DESIGN ADVISORY BOARD Tuesday, July 28, 2015 at 3:00 PM Conference Room 12, City Hall, Burlington, VT

1. **16-0007CA/MA & 16-0015CA; 329-351 North Ave, (RMW, Ward 4N) Eric Farrell**
Convert former orphanage & college building to 63 residential units and relocate college w/in building. Associated site improvements.

MEMORANDUM

To: The Design Advisory Board
From: Mary O'Neil, AICP, Senior Planner
RE: ZP16-0007CA/MA 351 North Avenue
Date: July 28, 2015

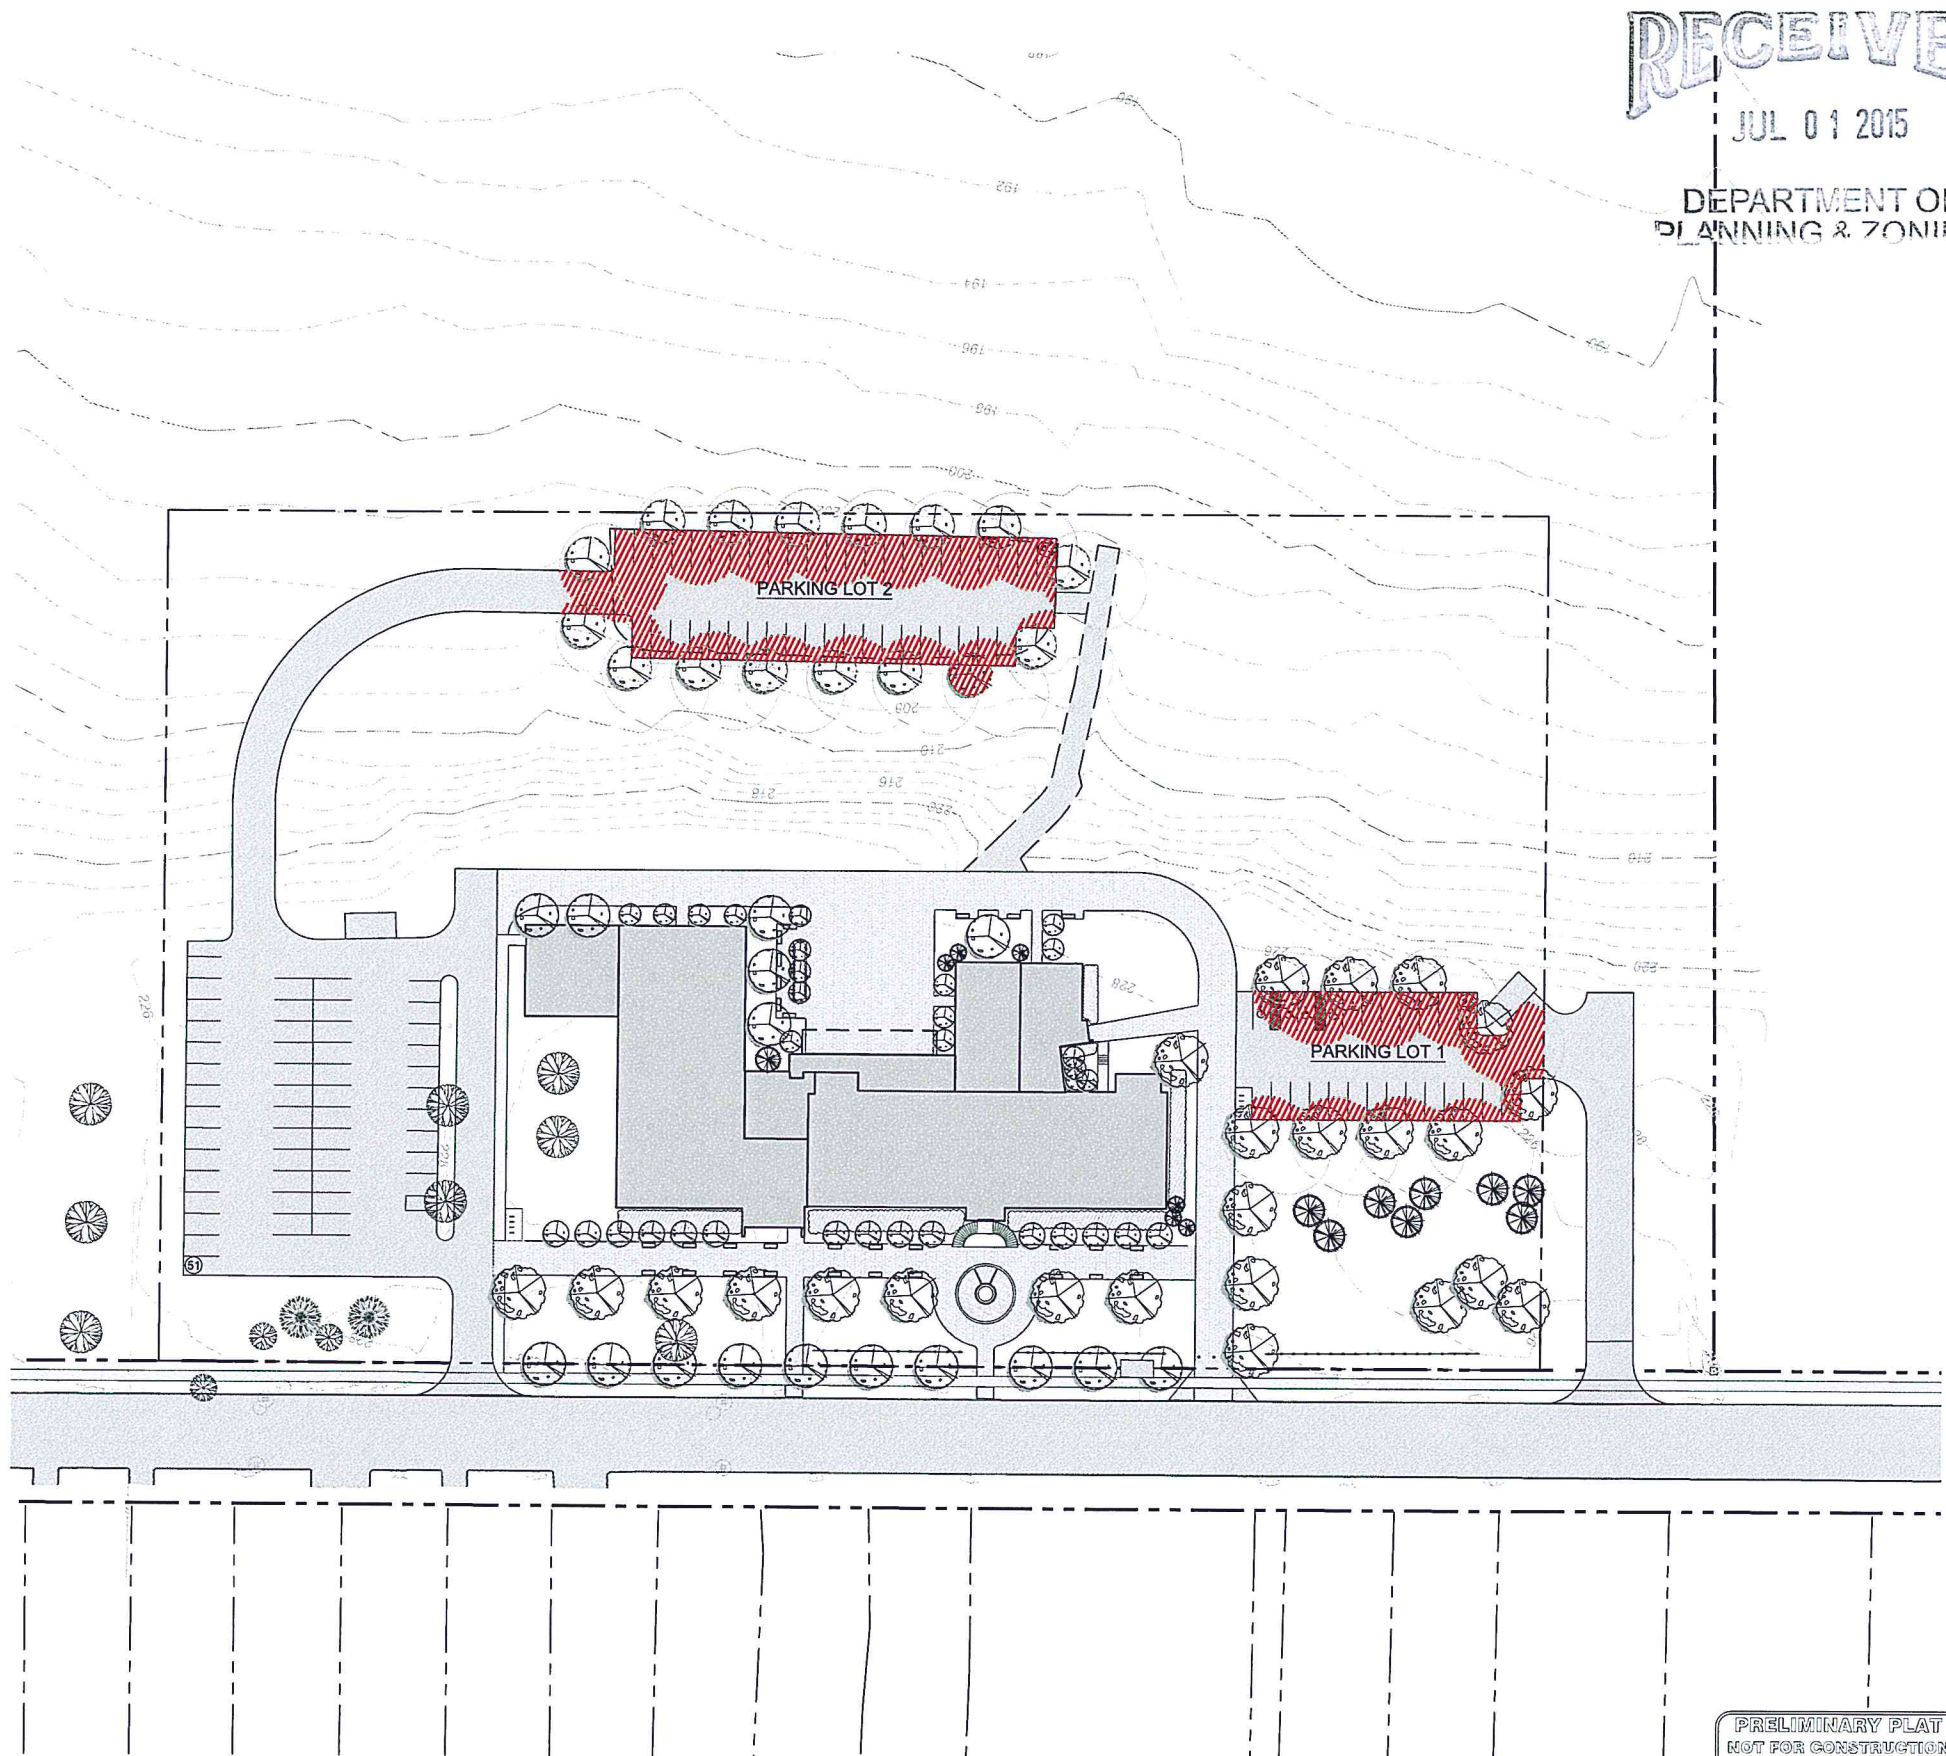
Plan L-104 illustrates parking lot shading for the westerly and northerly lots in excess of 50%; meeting this standard.

DATE: 06.30.15
A2.1

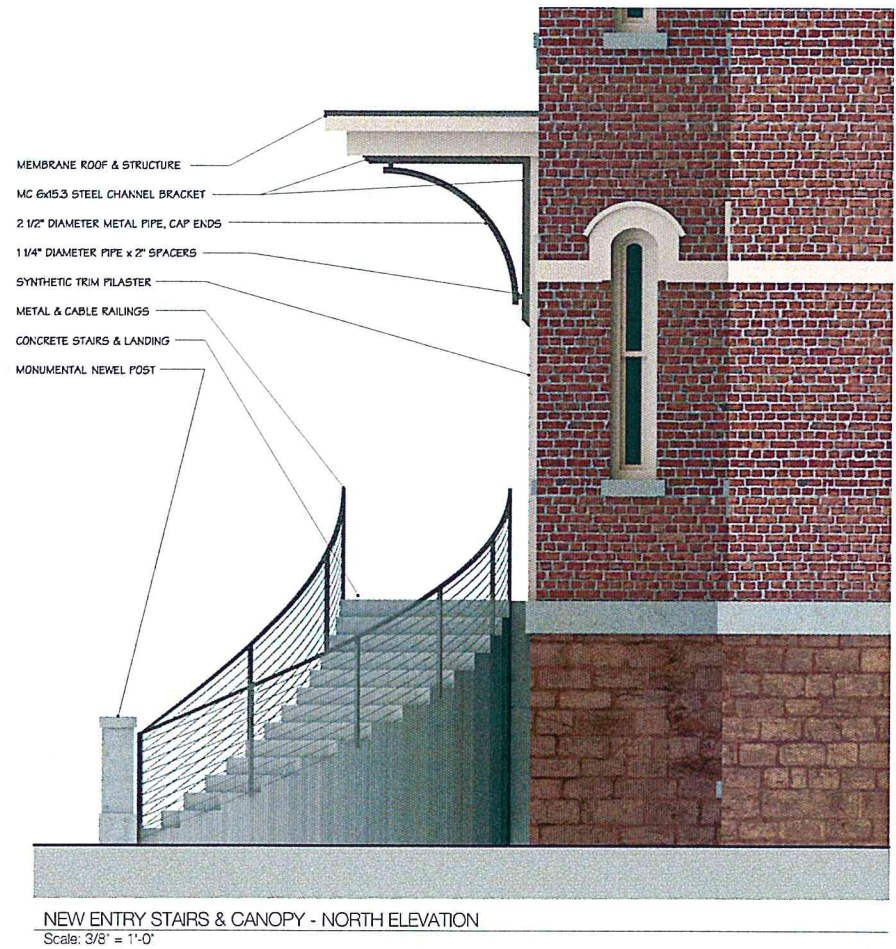
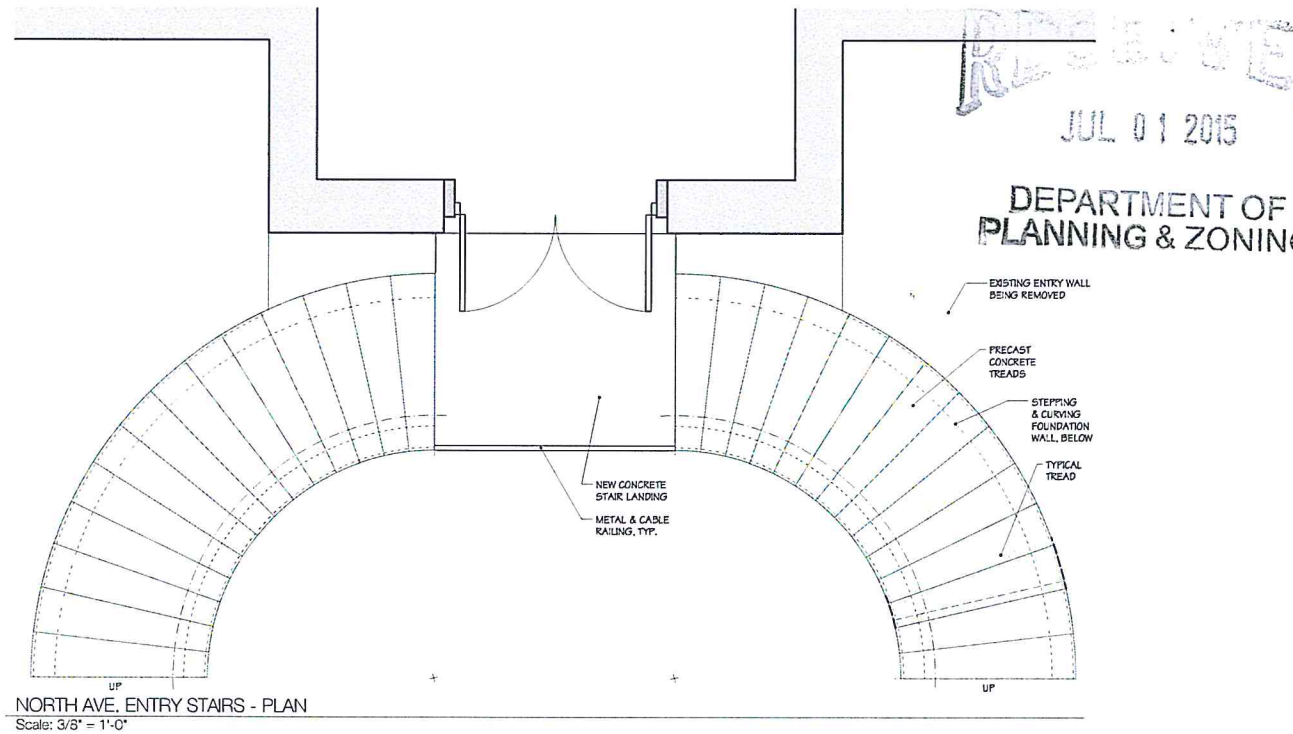
New rooftop mechanical equipment is proposed to replace Burlington College's existing equipment; see Plan A2.1. New code-compliant elevators are proposed for both the college and residential use.

There is no information about HVAC, potential antenna or mechanical installation other than replacement of rooftop equipment for the college. Any equipment proposed for the exterior must be integrated with the building design, and not added as an afterthought. As the principle building is historically sensitive, the siting and visual impact of any equipment will be assessed for appropriateness.

A1.1

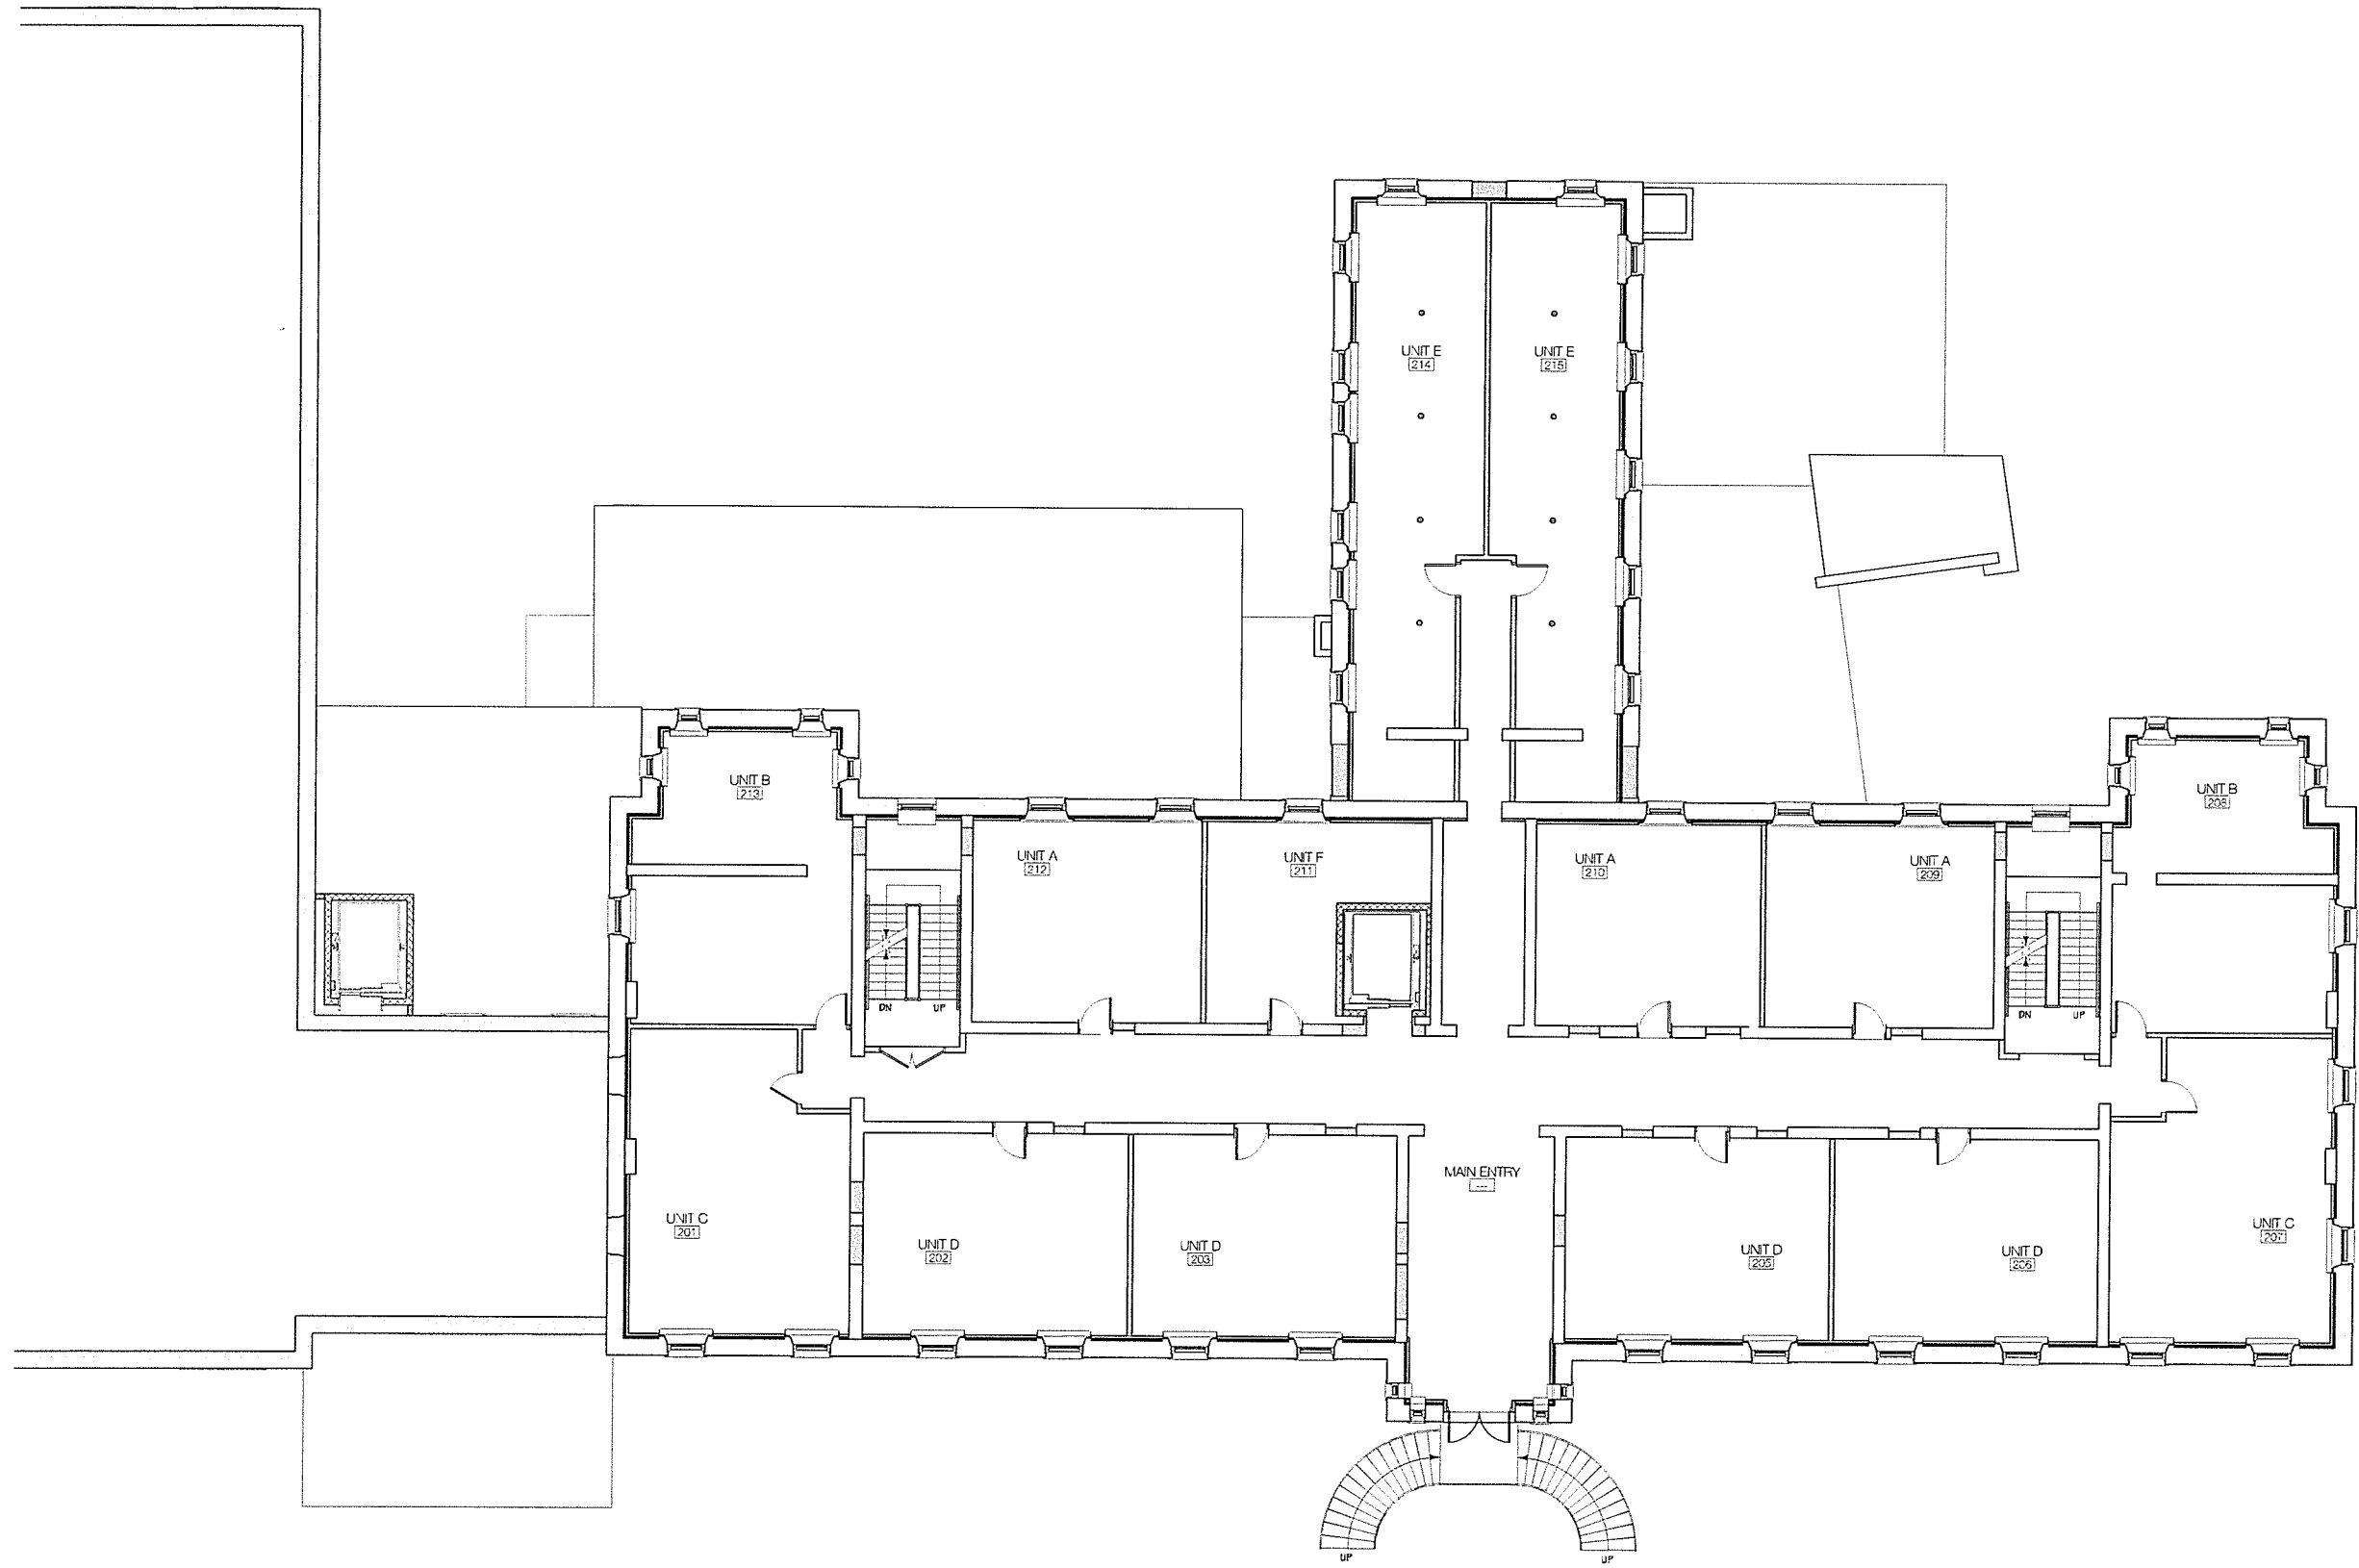
Bicycle parking is identified on the site plan (C2.0) and within floor plans (A1.1.) Exterior racks are within the northerly parking area abutting a pedestrian path; adjacent to the entranceway to the south of the buildings, and at the rear lobby entrance area. The type of bike rack is identified on Plan L202, and consistent with the *City of Burlington Bicycle Parking Guidelines*. Significant accommodation is made for interior bicycle storage as well.

Mailboxes are identified on the interior (Plan A1.1, Mail room east of Lobby.)
